Product / Process Change Notification

N° 2020-146-A

Introduction of an additional assembly and final test location at HANA Semiconductor (Ayutthaya, Thailand) Co., Ltd. for products in PG-DSO-8

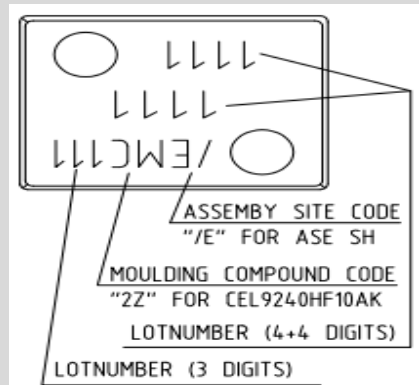
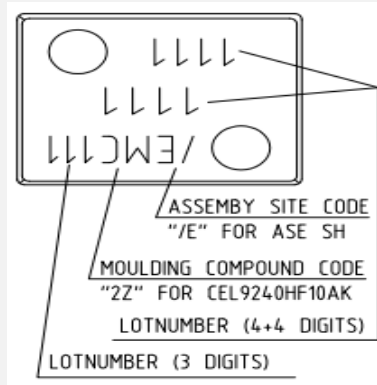
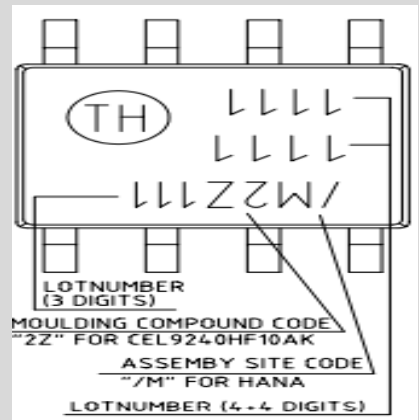
<u>Old</u>	<u>New</u>
<ul style="list-style-type: none"> • ASE Shanghai Inc. (Shanghai, P.R.C.) 	<ul style="list-style-type: none"> • ASE Shanghai Inc. (Shanghai, P.R.C.) or • HANA Semiconductor (Ayutthaya, Thailand) Co., Ltd.

Assembly and final test location

Assembly Site Code Marking

<ul style="list-style-type: none"> • E 	<ul style="list-style-type: none"> • E
--------------------------------------------------------------	--------------------------------------------------------------

or

- **M**
